CRYSTAL RIVER UNIT 3 NUCLEAR GENERATING PLANT

AMENDMENT TO FACILITY OPERATING LICENSE

Amendment No. 55
License No. DPR-72

SAFETY EVALUATION BY THE OFFICE OF NUCLEAR REACTOR REGULATION
SUPPORTING AMENDMENT NO. 55 TO FACILITY OPERATING LICENSE NO. DPR-72
FLORIDA POWER CORPORATION, ET AL
CRYSTAL RIVER UNIT NO. 3 NUCLEAR GENERATING PLANT
DOCKET NO. 50-302

FIGURE 2.2-1

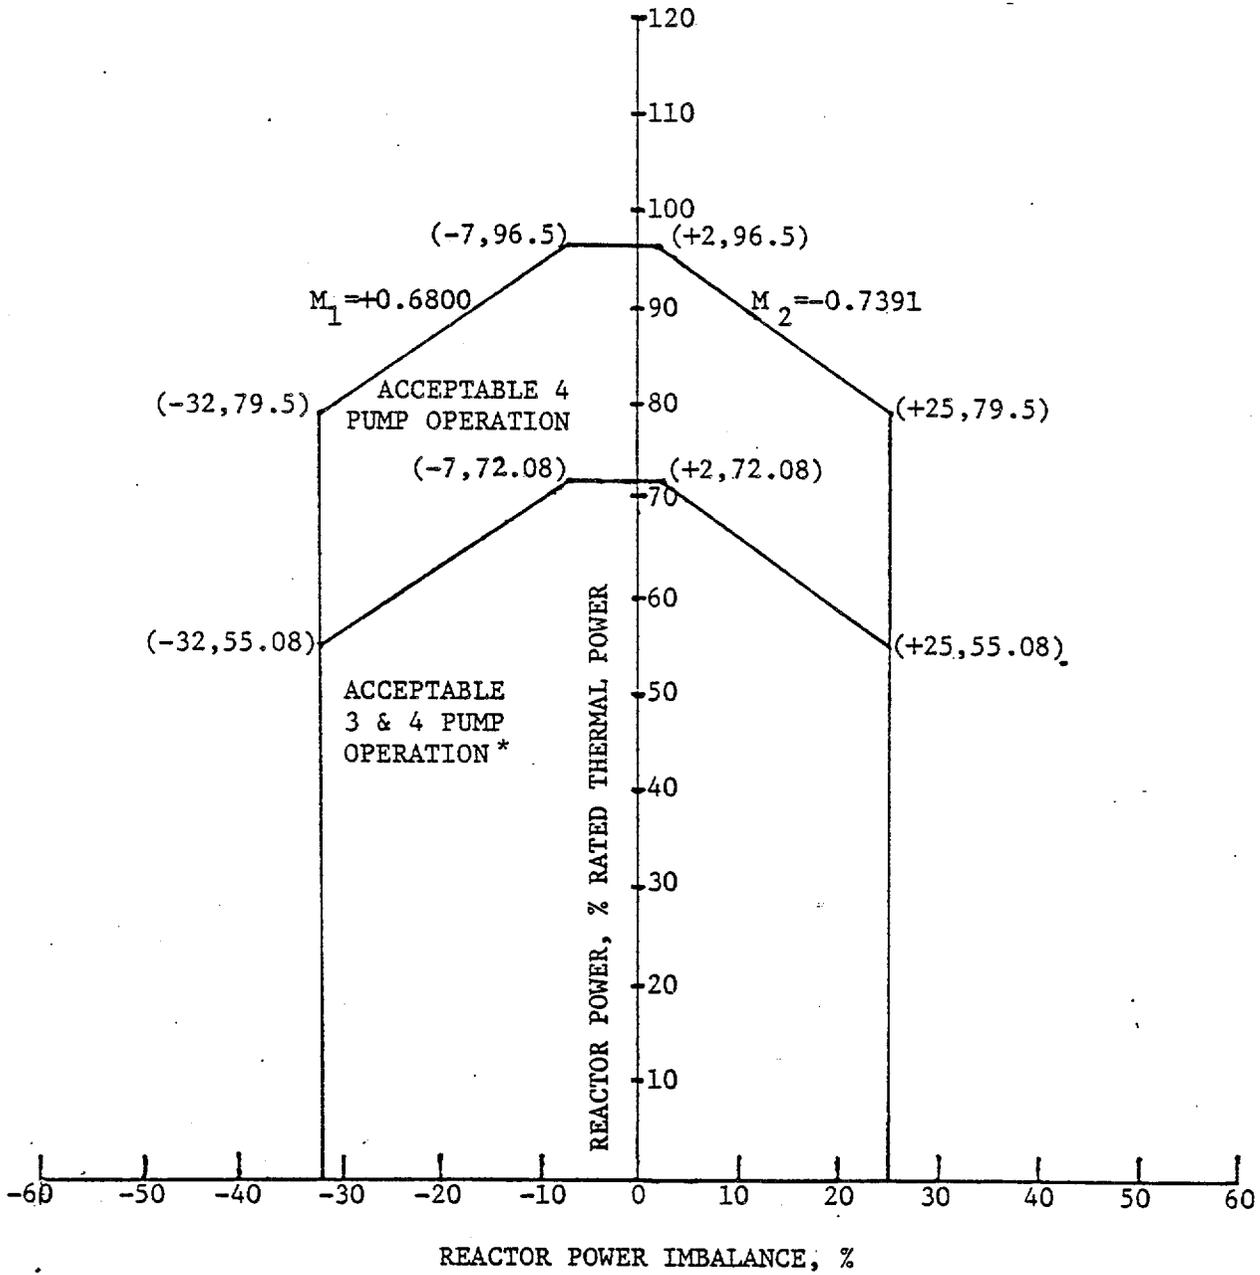
*Operation with three reactor coolant pumps with RCPs bypassed is not permitted.
